INCH-POUND
MIL-PRF-123B
AMENDMENT 5
6 July 1998
SUPERSEDING
AMENDMENT 4
21 May 1997

CAPACITORS, FIXED, CERAMIC DIELECTRIC,
(TEMPERATURE STABLE AND GENERAL PURPOSE), HIGH RELIABILITY,
GENERAL SPECIFICATION FOR

This amendment forms a part of MIL-C-123B, dated 6 August 1990, and is approved for use by all Departments and Agencies of the Department of Defense.

Example 6 "

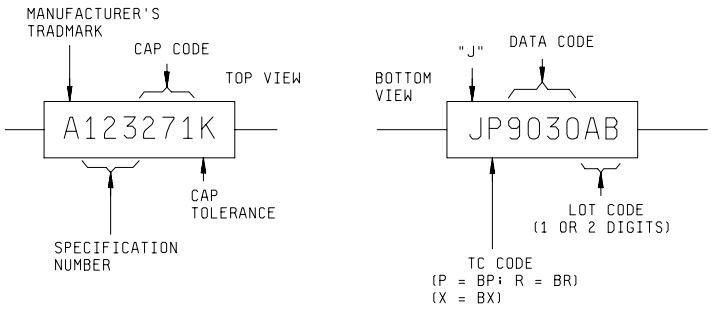
FIGURE 3, example 6, delete and substitute:

FIGURE C-7. Chip-outs. "

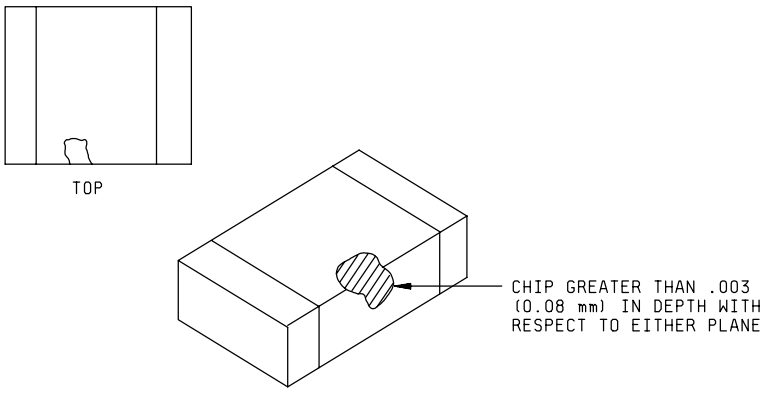
30.2.2.d, first sentence, delete and substitute:

"Edge chip-outs shall not be greater in depth than .003 inch (0.08 mm) with respect to either plane."

FIGURE C-7, delete and substitute:

FIGURE D-1. Lead-pull direction."

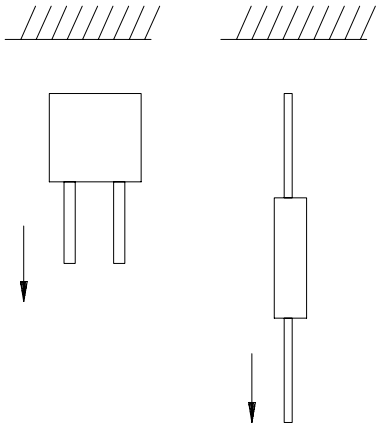
40.2, delete and substitute:

"40.2 Axial devices. Firmly clamp both leads into the test fixture. Gradually apply an increasing force (see figure D-1) until the limits specified in table XIV are exceeded."

FIGURE D-1, delete and substitute:
